10/530,325

Peter Titz

Office Action Summary	Application No. 10/530,325	Applicant(s) TITZ, PETER	
	Examiner Gregory J. Strimbu	Art Unit 3634

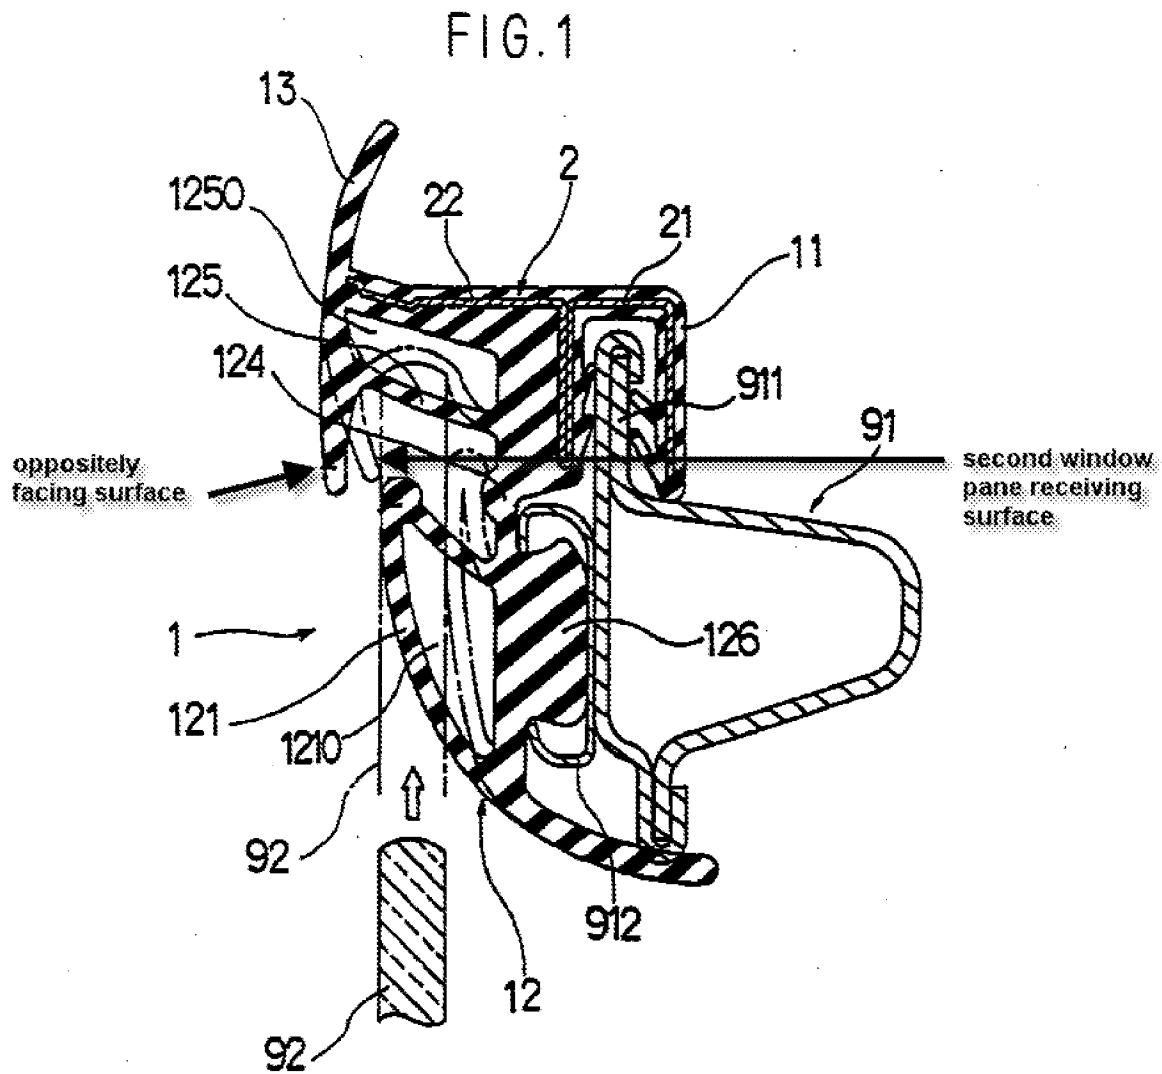
Claims 18, 21, 27, 28, 29 and 34 are rejected under 35 U.S.C. 103(a) as being unpatentable over Morita (US 5209019) in view of Nozaki et al. (US 5269101). Morita discloses a method of forming a sealing, trimming or guiding strip 1 for a window frame

the extruded material extends from the channel and has a second window pane receiving surface (labeled below) at the exterior side of the window pane and a generally oppositely facing surface (labeled below) directly visible from the exterior of the vehicle;
